**SUBDIVISION,
PLANNED UNIT DEVELOPMENT, &
ZONING AMENDMENT STAFF REPORT****Date: October 6, 2022****NAME**SRV Housing Partners, LLC (McCrory & Williams, Inc.,
Agent)**SUBDIVISION NAME**

SRV KO Subdivision

Subdivision approval to create two (2) legal lots of record from three (3) legal lots of record; Planned Unit Development Approval to allow multiple buildings on a single building site, and shared access between multiple building sites on a private street; and Rezoning from LB-2, Limited Neighborhood Business District and R-3, Multi-Family Residential District, to R-3, Multi-Family Residential District.

SITE PLAN

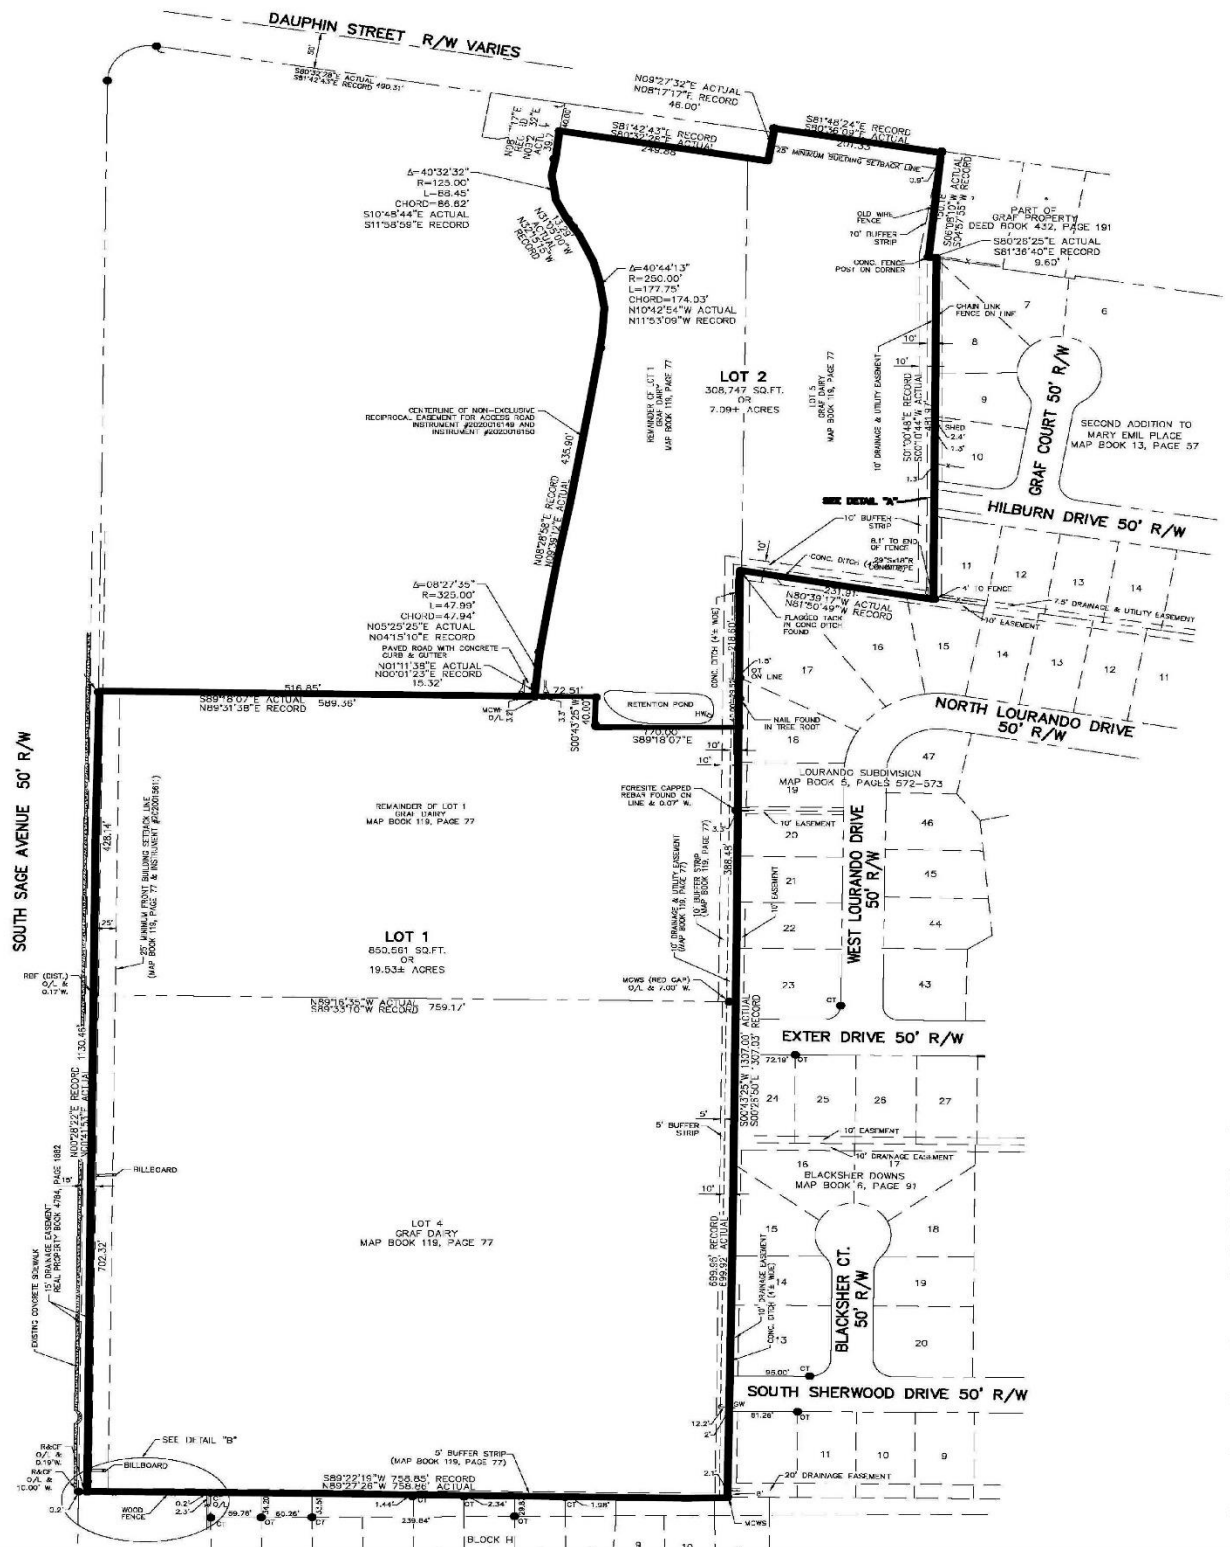
The preliminary site plan depicts a 5-foot buffer strip where the site abuts R-1, Single-Family Residential District, however it should be noted that the Zoning Ordinance requires a minimum 10-foot residential buffer where commercial development (Lot 2) abuts residential. As the Subdivision Regulations do not require this buffer, if approved, it should either be removed from the Final Plat, or revised to show 10-feet.

As the proposed development is to have 358 dwelling units, 537 parking spaces are required. The site plan submitted depicts 446 parking spaces in the parking lot, with 96 additional parking spaces located within the proposed freestanding garages, for a total of 542 parking spaces available. If approved, a compliant photometric site plan will be required at the time of permitting.

As the site abuts an R-1, Single-Family Residential District to the East, a compliant residential buffer should be required. The site plan submitted depicts a wooden privacy fence along the property line, but does not mention the height. If approved, the site plan should be revised to state that the fence will be a minimum of six-feet tall, not to exceed three-feet tall within the 25-foot front setback along South Sage Avenue.

The applicant states that both the entrance to the site from South Sage Avenue and the existing private street will have electronic gates, but the site plan submitted does not depict the proposed gate locations. If approved, the site plan should be revised to depict the gate locations, state that they are electronically operated, and provide a minimum of one (1) queuing space (9-feet x 20-feet) to provide room for vehicles to pull off the right-of-way while waiting for the gate to open. The gate should also be designed in such a way to comply with Fire Department access requirements.

The applicant states that existing trees on the site will be preserved, but does not indicate any on the site plan or preliminary plat submitted. If approved, all existing trees to be preserved should be indicated on the site plan with their size and species provided. Furthermore, the proposed development will be required to fully comply with tree planting and landscape area requirements, with tree planting to be coordinated with staff.

The site plan submitted depicts the proposed trash compactor in a compliant location, but makes no mention of any enclosure or sanitary sewer connection. If approved, the site plan should be revised to include notes the trash compactor will comply with these requirements.

- 1) revision of the site plan to show the existing right-of-way along Dauphin Street;
- 2) retention of the existing right-of-way width for South Sage Avenue;

- 3) retention of the lot sizes in square feet and acres;
- 4) placement of a note stating that no structures are allowed in any easement without the easement holder's permission;

- 5) revision of the depicted 5-foot buffer adjacent to residential property be revised to 10-feet;
- 6) depiction of the 25-foot front setback along all street frontages;

- 7) placement of a note on the site plan prohibiting Lot 1 from direct access to both Exter Drive and South Sherwood Drive;
- 8) placement of a note on the Final Plat prohibiting Lot 2 from direct access to both Hilburn Drive;

- 9) placement of a note on the site plan stating the wooden privacy fence abutting residential property will be a minimum of six-feet tall, not to exceed three-feet within the 25-foot setback along South Sage Avenue;

- 10) placement of a note on the site plan providing the maximum structure height proposed, not to exceed 45-feet unless compliant with Section 64-4.C.2. of the Zoning Ordinance;

- 11) provision of a compliant photometric site plan at the time of permitting;
- 12) revision of the site plan to depict the gate locations, state that they are electronically operated, and provide a minimum of one (1) queuing space (9-feet x 20-feet), while complying with Fire Department access requirements;

- 13) revision of the site plan to depict all existing trees to remain on site, labeled with their size and species;

- 14) placement of a note on the site plan stating the development will fully comply with tree planting and landscape area requirements, with tree plantings to be coordinated with staff;
